RE: **Lot 39 Block 6, Volcano Cliffs, Unit 18, SAD 228**
6623 Sujeto NW
Grading and Drainage Plan
Engineers Stamp Date 2/28/20 (D10D003M39)

Based upon the information provided in your submittal received 2/28/20, this plan is approved for Grading Permit.

DRAINAGE AND TRANSPORTATION INFORMATION SHEET (REV 6/2018)

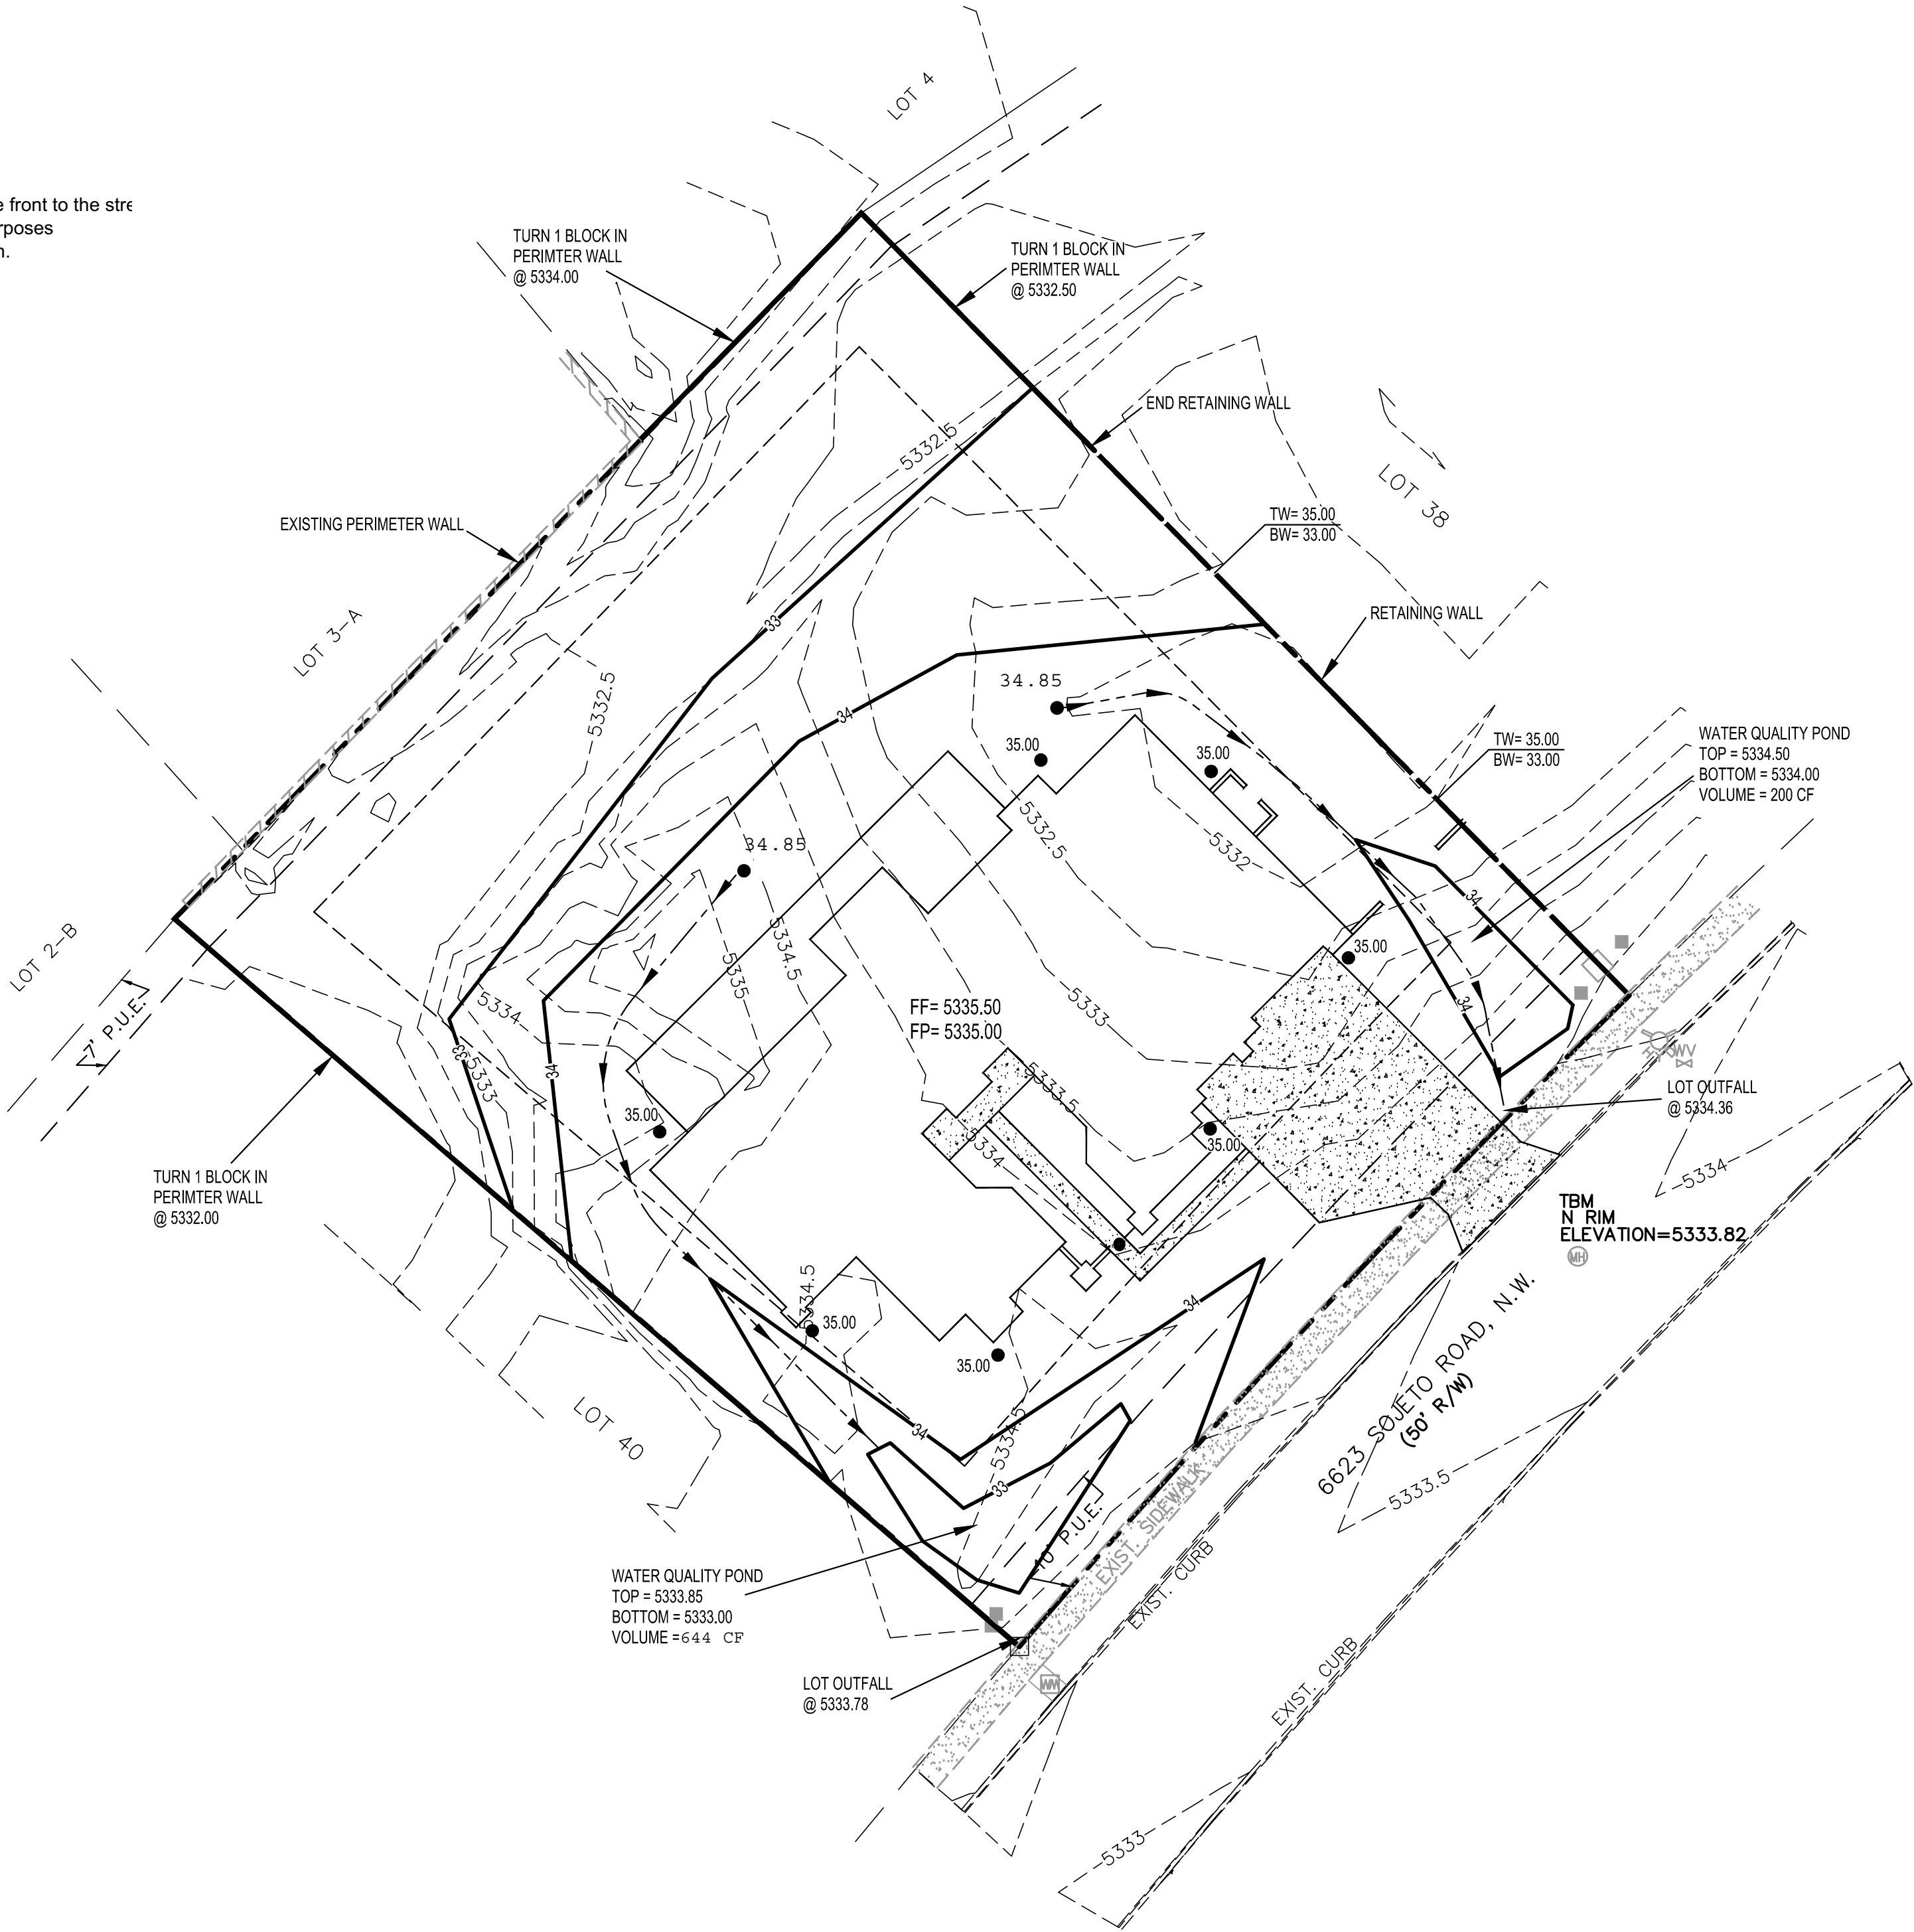
Prior to Building permit approval a Pad Certification will be required, provided by the Engineer or a registered Land Surveyor.

Advise the owner contractor not to use dirt as a ramp to climb the curb, use lumber or crusher fines for this purpose.

Reiterate to the Owner/Contractor that a separate permit for a garden/retaining wall must be obtained with the approved G&D plan and Pad Certification. Also, if a swimming pool is to be placed the grading and drainage plan will change and will need to be resubmitted.

Prior to Certificate of Occupancy release, Engineer Certification per the DPM checklist is required.
